Site Audit Report and Site Audit Statement for the Remedial Action Plan, Hydro Aluminium Kurri Kurri Smelter Site Audit

Part B2 - Appropriateness of RAP for Smelter Area

06-Jul-2018

CONCEPTUAL CONTAINMENT CELL CROSS SECTIONS
 HYDRO ALUMINUM SMELTER KURRI KURRI
 NEW SOUTH WALES, AUSTRALIA

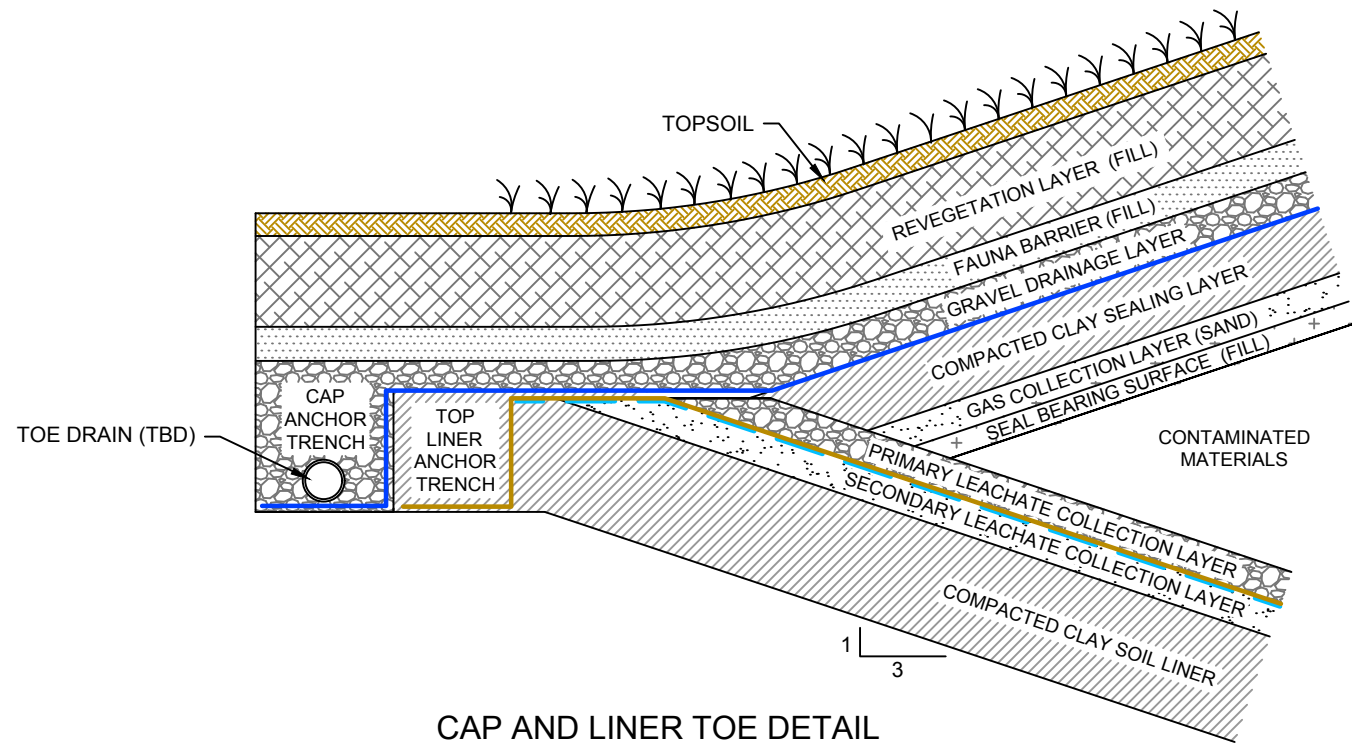
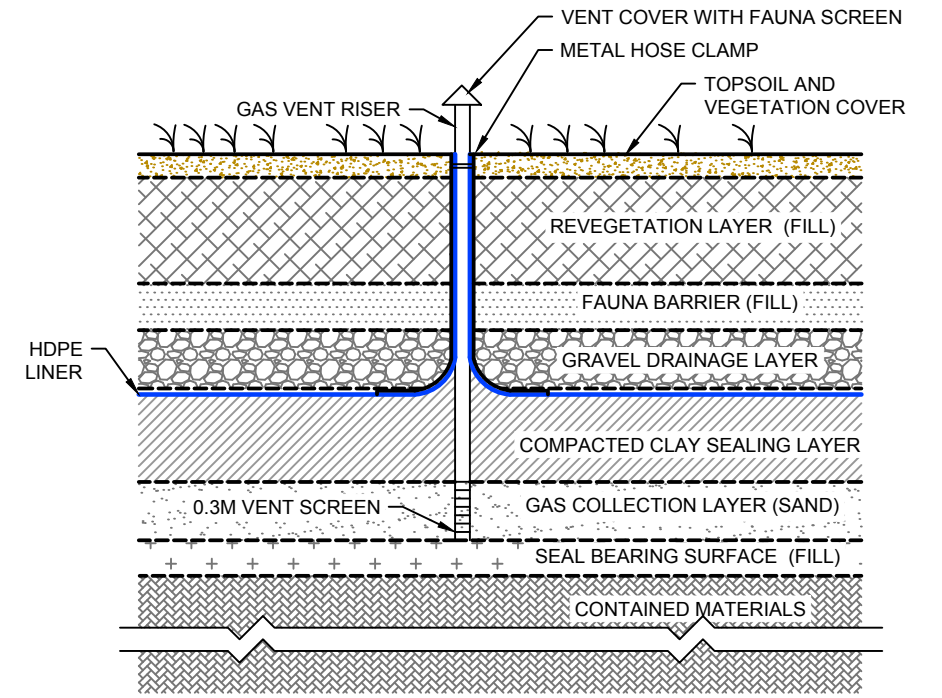
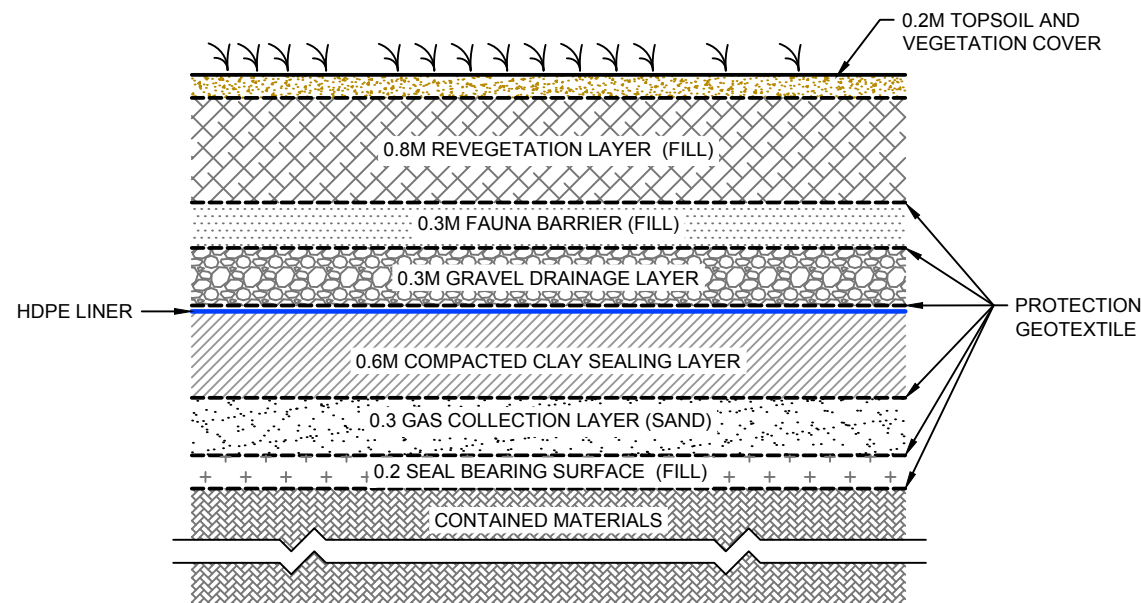
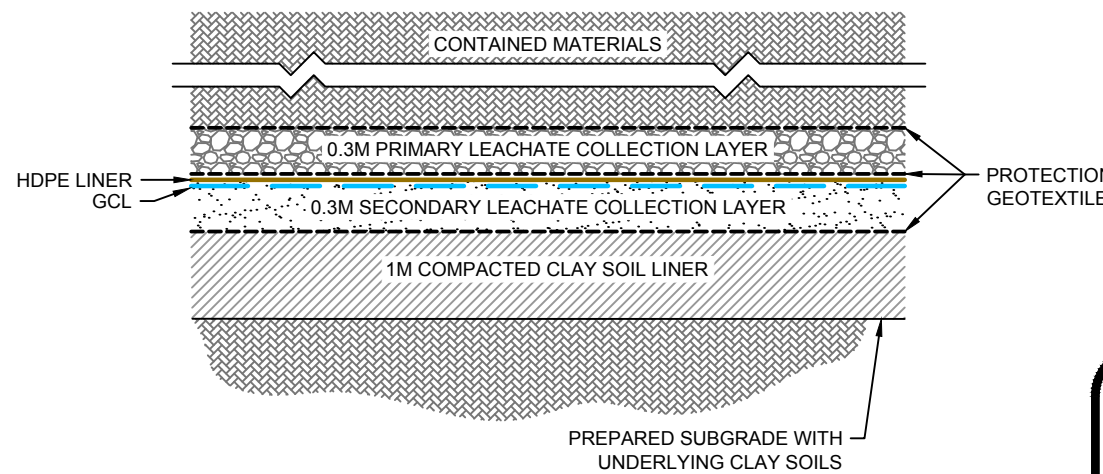
6	That the suitability of the containment cell design be independently verified.	This comment has been identified by NSW EPA to ensure the proposed containment cell meets current best practice and is appropriate for the degree and extent of contamination identified in the material to be placed in the containment cell.
